SERVICE DIRECTIVE BULLETIN NO. 0126

Revision 1

DATE: July 6, 2023

1. SUBJECT: Cabin Bellcrank Mounts and Bellcrank Attachment Inspection
2. MODEL: F-28A, 280, F-28C, F-28C-2, F-28C-2R, 280C, F-28F, F-28F-R, 280F, and 280FX
3. EFFECTIVITY: All S/N (Note special exclusion in paragraph 5.3.)

Figure 1. Cyclic Control System Schematic (Top); Bellcrank Cabin Mounts (Bottom)

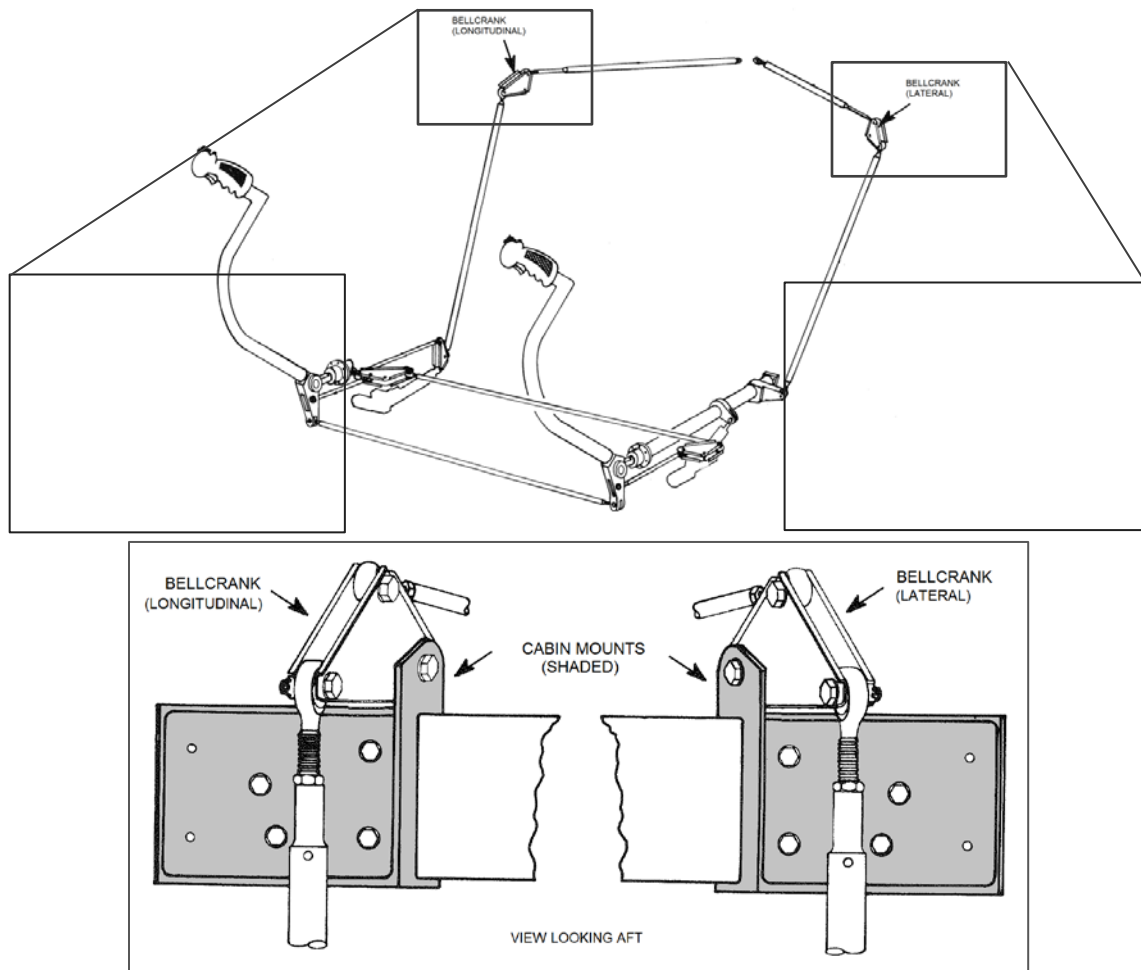
- 6.1 Perform NDT inspection of the upper cabin mounts (lateral and longitudinal) (Figure 1 and Figure 4-a, 4-b).
 - 6.1.1 Remove the seat structure cover.
 - 6.1.2 Remove the left and right fuel tanks.
 - 6.1.3 Detach the control tube backwall cover, if equipped (Figure 2).
 - 6.1.3.1 Remove the four screw fasteners.
 - 6.1.3.2 Cut the cable ties on both ends of the rubber boot.
 - 6.1.3.3 Break the seal between the cover and the backwall and the fire curtain.
 - 6.1.3.4 Move the boot and cover aft to gain direct access to the cabin mount.

Figure 4. Upper Cabin Mount Inspection (LH Shown)

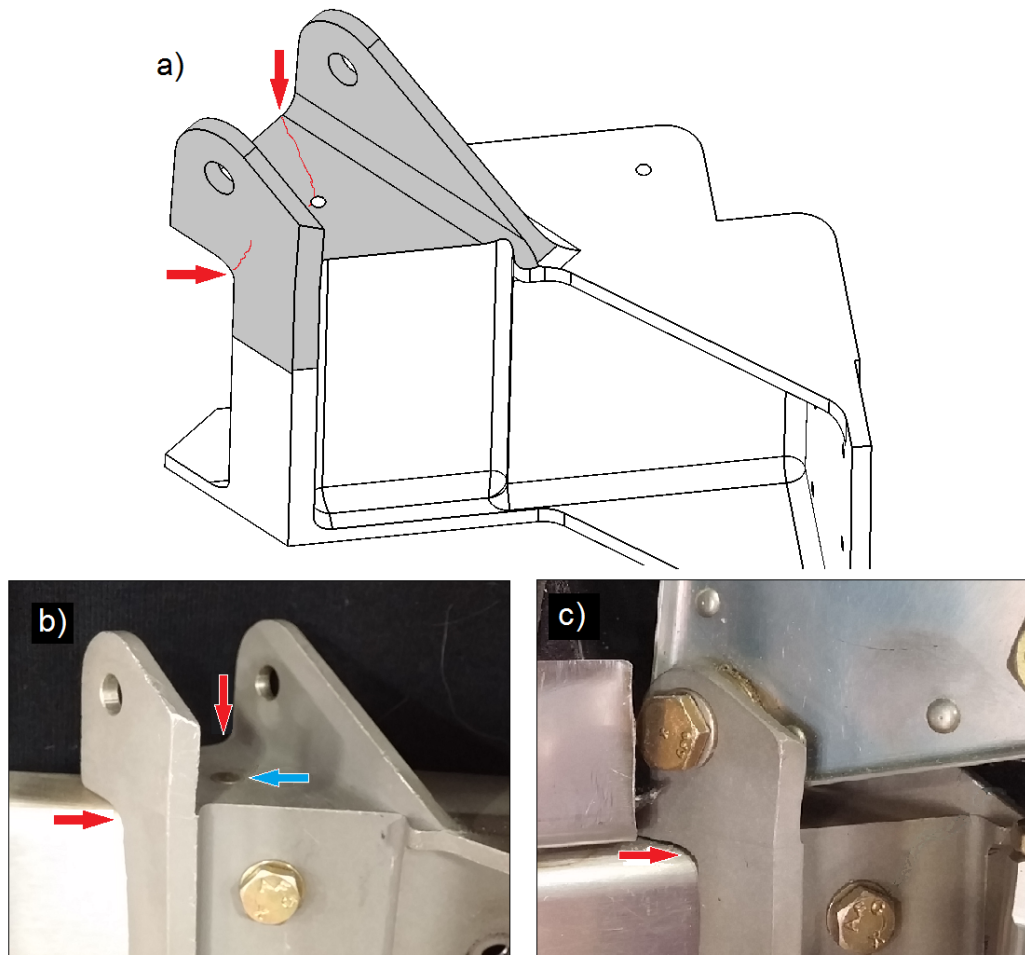
- 6.1.7 Inspect the cabin mount for cracks using dye penetrant method. Follow the manufacturer's instructions. Refer to Figure 4 for the area to inspect.
- 6.1.7.1 Positive indication – Reject the cabin mount and replace with an airworthy cabin mount. Contact Enstrom Product Support for the replacement procedure.
- 6.1.8 If no indication, remove the dye products from the area per the manufacturer's instructions and inspect all visible rivets (countersunk and universal head) for condition and looseness. Replace loose rivets, as necessary.
- 6.1.9 Repeat 6.1.3 through 6.1.8 for the opposite side cabin mount or proceed to step 6.3.

- 6.2.3 Use a solvent (denatured alcohol, mineral spirits, or equivalent) to remove grease or oil residue from the cabin mount.
- 6.2.4 With a bright light source and inspection mirror, visually inspect the cabin mounts for cracks, particularly in the area indicated in Figure 4-c.

- 6.2.4.1 If a crack is detected, reject the cabin mount and replace with an airworthy cabin mount. Contact Enstrom Product Support for the replacement procedure.

- 6.2.5 If no crack is detected, inspect all visible rivets (countersunk and universal head) for condition and looseness. Replace loose rivets, as necessary.

Figure 5. Hardware Stack-up Calculation

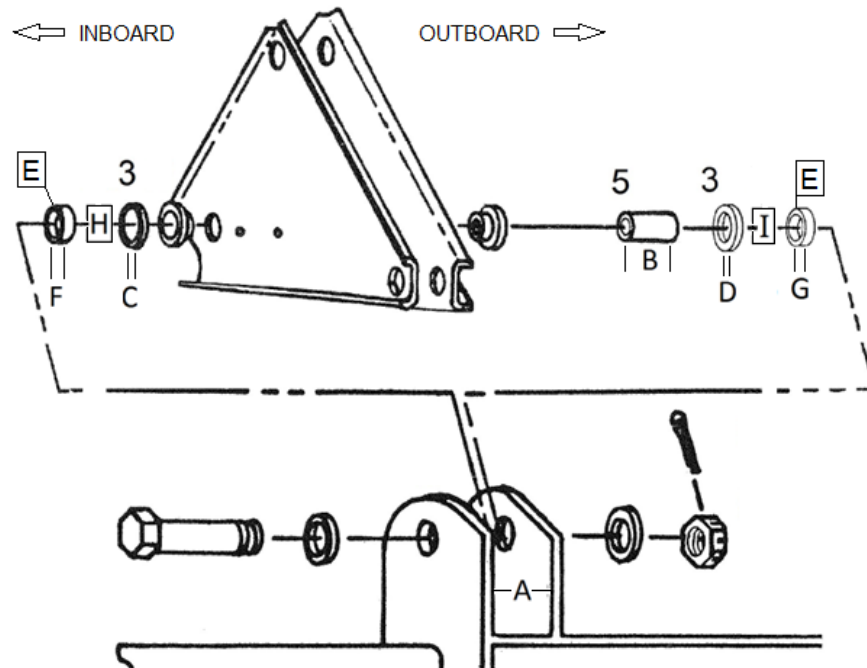
Revision 1 modifies the hardware assembly between the ears of the cabin mount in cases where the hardware stack-up may be deficient.

This procedure compares the measurement between the cabin mount ears and the calculated length of the hardware stack-up. Any deficiency in hardware stack-up is corrected by installing spacer P/N 28-16209-x (if required) and shim P/N 28-16217-x as required.

- 6.4 Hardware stack-up for the LH cabin mount. See Figure 5.
- 6.4.1 Measure the distance between the 0.250 inch diameter holes of P/N 28-11307-1 mount. This is Measurement A.

- 6.4.2 Measure the length of spacer (Item 5). This is Measurement B.
- 6.4.3 Measure the thickness of washer (Item 3, inboard). This is Measurement C.
- 6.4.4 Measure the thickness of washer (Item 3, outboard). This is Measurement D.

- 6.4.5 Solve for Δ using this formula: $A - (B + C + D) = \Delta$
- 6.4.6 Determine spacer (Item 4) selection from this formula: $\Delta / 2 = E$
- 6.4.6.1 Select spacer P/N 28-16209-1 if E value is ≥ 0.101 inch.

- 6.4.6.2 Select spacer P/N 28-16209-11 if E value is ≤ 0.100 inch.
- 6.4.7 Measure the thickness of spacer (Item 4, inboard). This is Measurement F.
- 6.4.8 Measure the thickness of spacer (Item 4, outboard). This is Measurement G.

- 6.4.9 Determine the shim thickness required for the inboard side. This will be Measurement H.
- 6.4.9.1 Solve for H using this formula: $E - F = H$
- 6.4.9.2 Select P/N 28-16217-x as required to equal H.

- 6.4.10 Determine the shim thickness required for the outboard side. This will be Measurement I.
- 6.4.10.1 Solve for I using this formula: $E - G = I$

- 6.4.10.2 Select P/N 28-16217-x as required to equal I.
- 6.4.11 Verify that $(B + C + D + F + G + H + I) = A (+0/-0.001)$

- 6.4.12 Install P/N 28-16217-x (Item 16) shims, as required, between Item 3 and Item 4, inboard and outboard, respectively.
- 6.5 Torque (50-70 in-lb/5.6-7.9 Nm) and safety the nut.
- 6.6 Repeat steps 6.4 and 6.5 for the RH cabin mount.
- 6.7 Reinstall the control tube covers, if installed.
- 6.7.1 Reinstall the four cover fasteners.
- 6.7.2 Reposition the boot and secure with cable ties.
- 6.7.3 Seal the cover edge with RTV sealant (Dow Corning 732, or equivalent).
- 6.8 Reinstall the fuel tanks.
- 6.9 Reinstall the seat structure cover.
7. PARTS:
